Porsche Carrera Cup France 2021

Note Technique 26/2021

MANCHONS DE RENFORT BERCEAU AV

Nouvelle vis (WHT.008.757) avec manchon

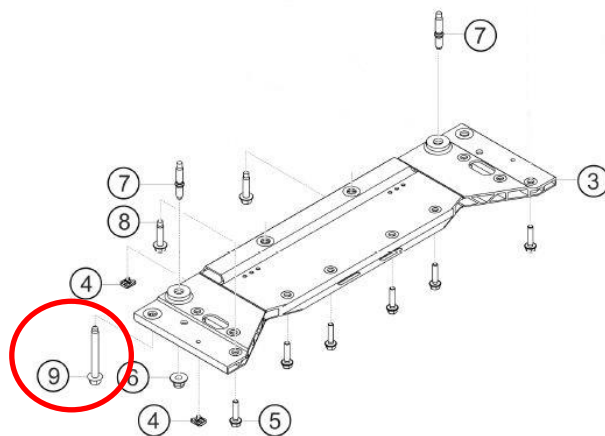
Porsche Motorsport vous informe que de nouvelles vis de hauteur de caisse et manchons de renfort sont disponibles pour votre Porsche 991 GT3 Cup (type 992). Toutes les pièces nécessaires seront distribuées gratuitement par l'organisation de la PCCF à leurs concurrents. Pour toutes les voitures qui ne participeront plus à la PCCF en 2022, ces pièces peuvent être demandées gratuitement auprès de gt3cup.support@porsche.de en fournissant le numéro de châssis concerné.

Les voitures qui sont déjà équipées des manchons de renfort dès leur sortie d'usine sont également équipées des nouvelles vis de hauteur de caisse. Les valeurs de hauteur de caisse demeurent inchangées en cas d'utilisation de ces nouvelles pièces.

Porsche Motorsport recommande que les nouvelles vis de hauteurs de caisse ne soient serrées qu'une seule fois, et remplacées après chaque démontage.

1 – Retirer la vis de hauteur de caisse (N.913.041.01 ou N912.534.01)

2 – Nettoyer la surface de contact entre le berceau et le nouveau manchon

3 – Insérer le manchon de renfort dans le berceau

4 – Visser la nouvelle vis de hauteur de caisse (WHT.008.757) et serrer à 70N.m+180°

New bolt (WHT.008.757) with sleeve

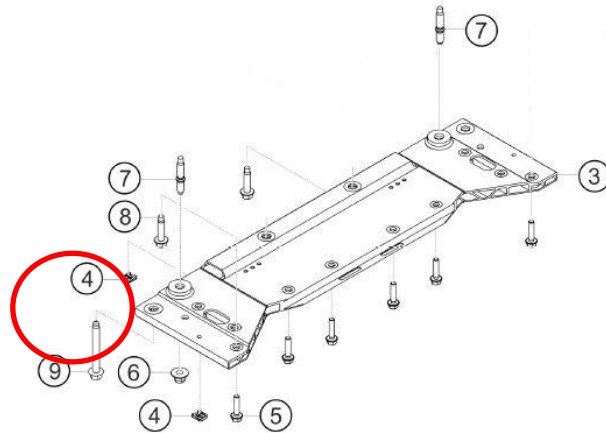
Porsche Motorsport informs that new ride height measurement bolts and reinforcement sleeves are available for the Porsche 911 GT3 Cup (992). All necessary parts will be distributed free of charge by your local series organization. For cars not participating in a one-make championship, parts can be requested and ordered free of charge at gt3cup.support@porsche.de by stating the chassis number of the car. Cars that have reinforcement sleeves installed ex works are already equipped with new ride height measurement bolts. The car's ride height measurement values remain unaffected by the new parts.

Porsche Motorsport recommends tightening the new ride height measurement bolt only once and replacing it every time it's loosened.

- 1 – Loosen and remove the bolt for ride height measurement (N.913.041.01 or N.912.534.01)

- 2 – Clean the surface of the subframe that contacts the reinforcement sleeve

- 3 – Insert the reinforcement sleeve into the subframe

- 4 – Screw in the bolt for ride height measurement (WHT.008.757) and tighten to 70 Nm + 180°
